Your Ref
APP/16/00473
Our Ref
PLAN-014250
Date
20/06/2016

Proposal: Demolition of existing 4 bed detached house and construction of new 4 bed detached house.

Site: 11 Lower Road, Havant, PO9 3LH.
APP/16/00473

Screen Print

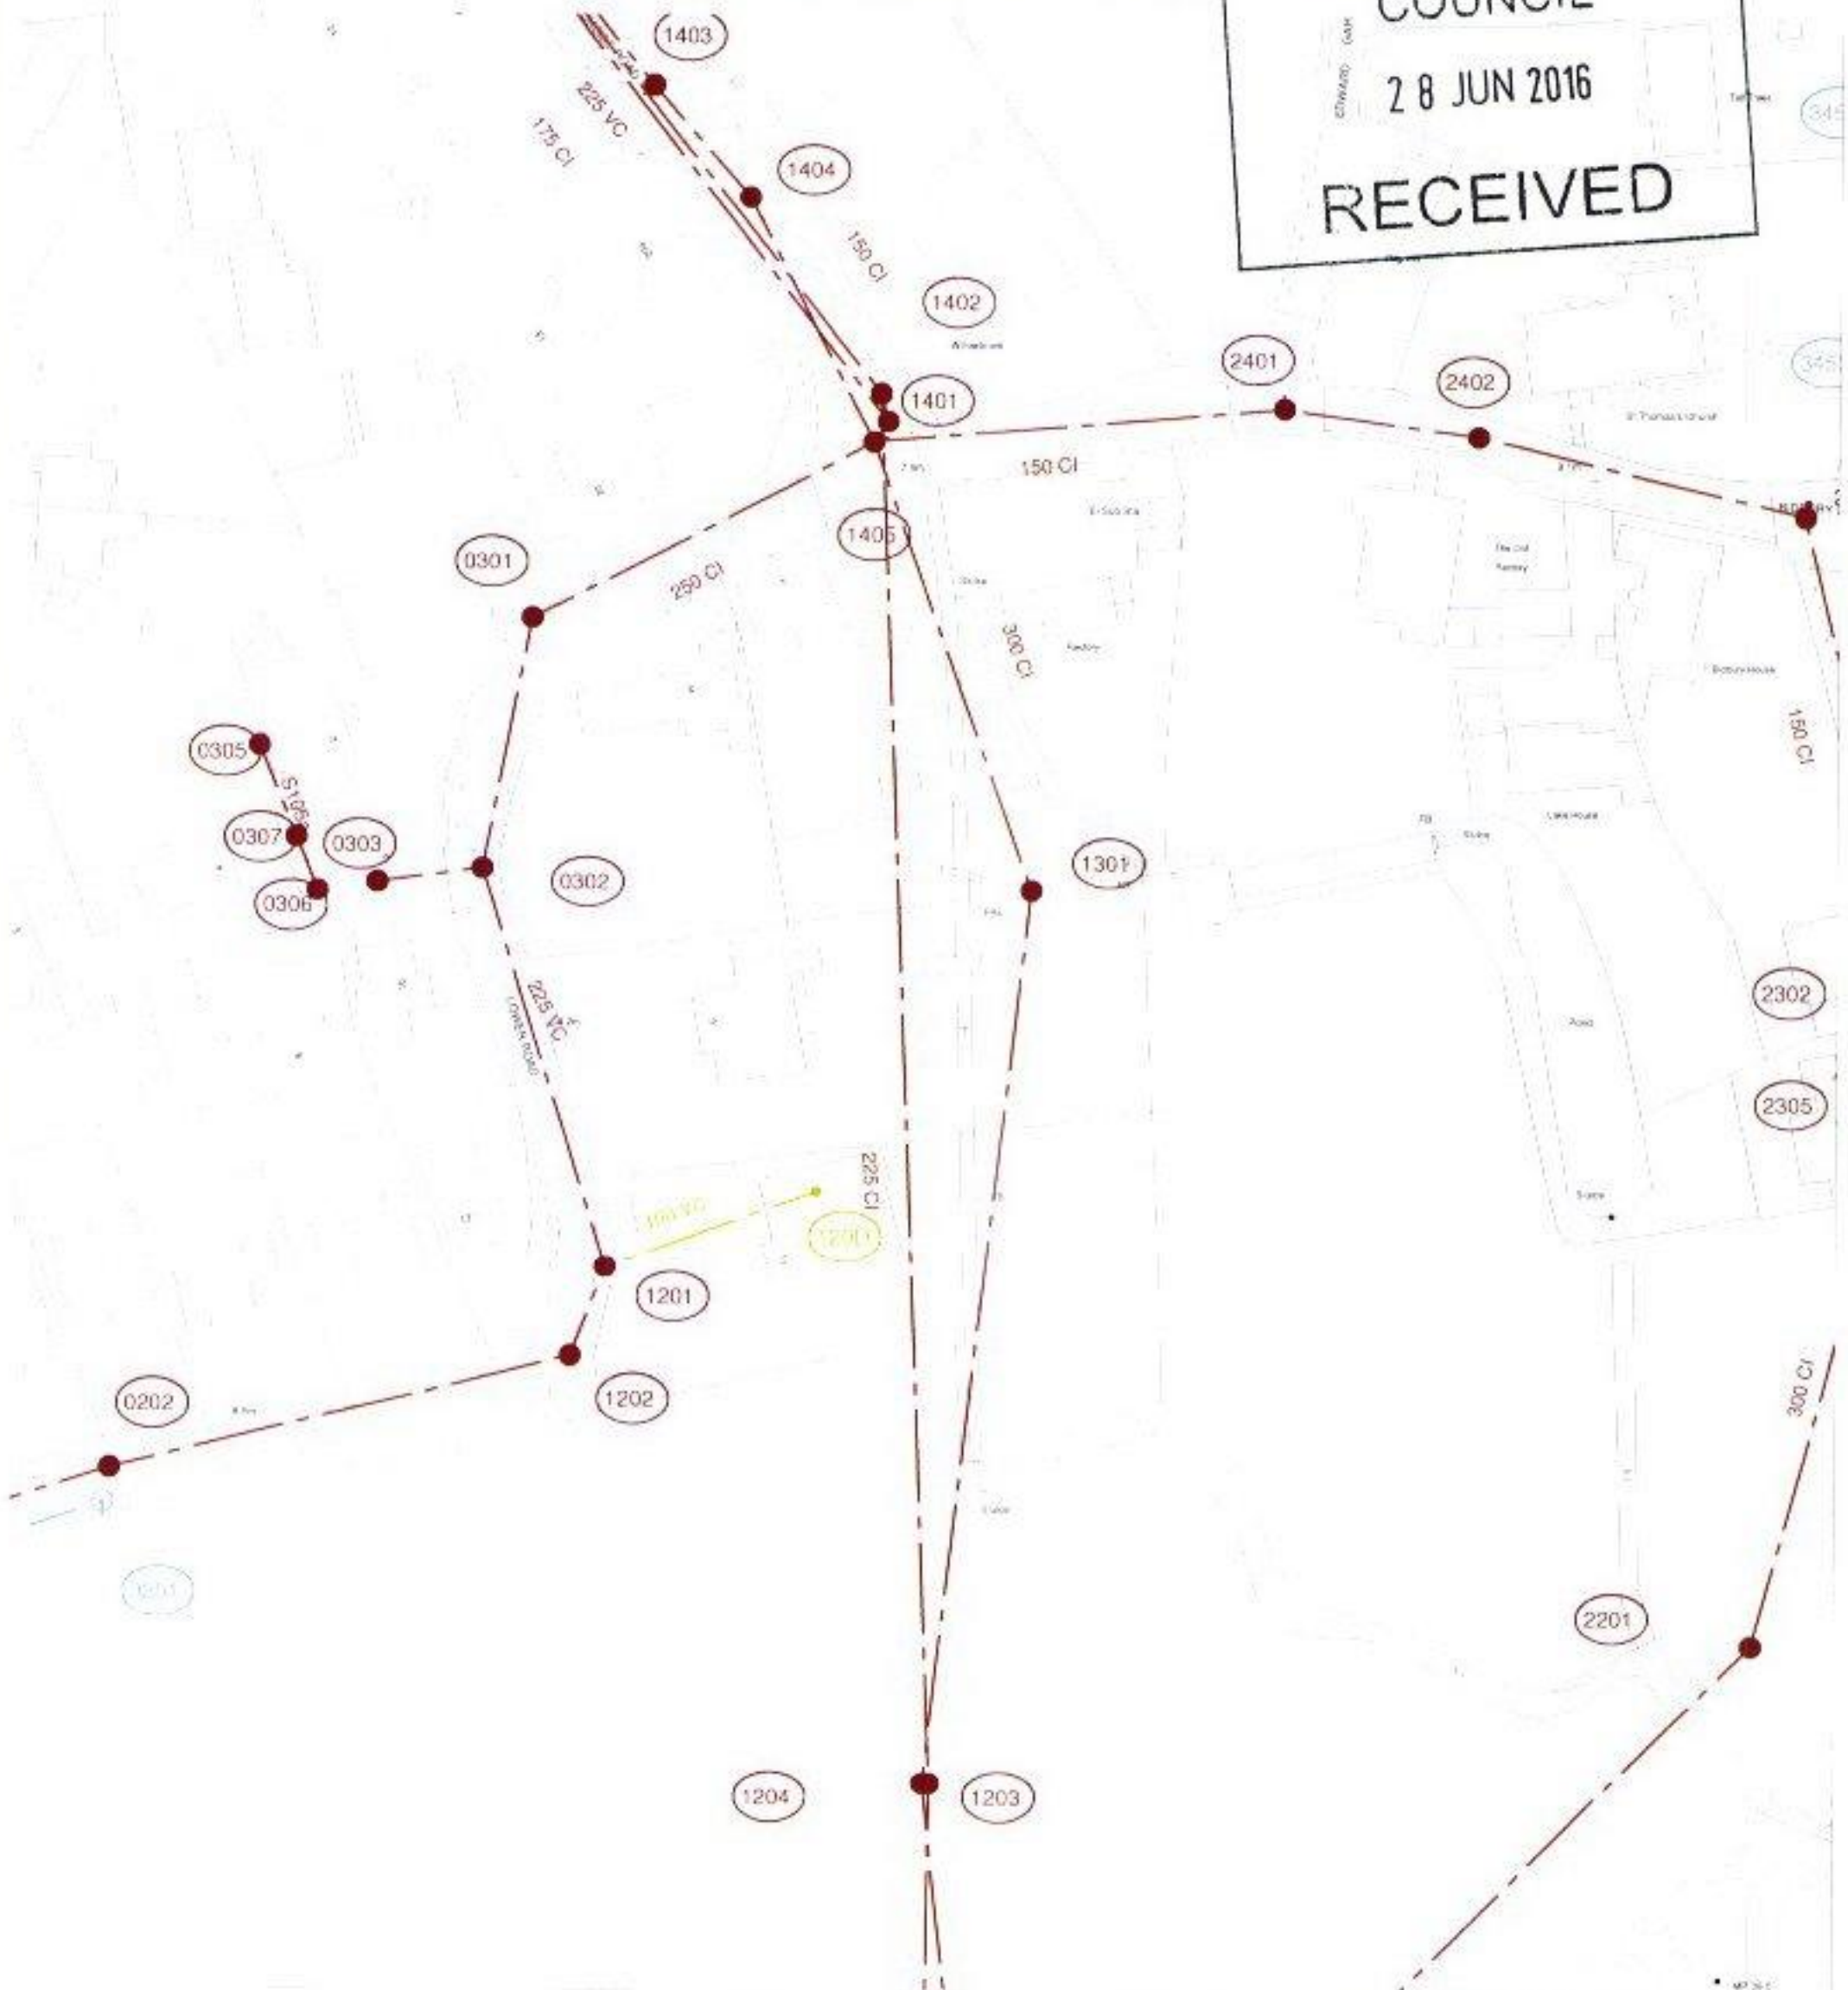
Please find attached a plan of the sewer records showing the approximate position of a public foul sewer within the site. The exact position of the public sewers must be determined on site by the applicant before the layout of the proposed development is finalised.

1. The 100mm & 225mm diameter sewer requires a clearance of 3 metres either side of the sewer to protect it from construction works and allow for future access for maintenance.
2. No development or new tree planting should be located within 3 metres either side of the centreline of the public sewer
3. No new soakaways should be located within 5 metres of a public sewer.
4. All other existing infrastructure should be protected during the course of construction works.

Alternatively, the applicant may wish to amend the site layout, or combine a diversion with amendment of the site layout. If the applicant would prefer to advance these options, items (1) – (4) above also apply.

In order to protect drainage apparatus, Southern Water requests that if consent is granted, a condition is attached to the planning permission. For example "The developer must advise the local authority (in consultation with Southern Water) of the measures which will be undertaken to divert the public sewers, prior to the commencement of the development."
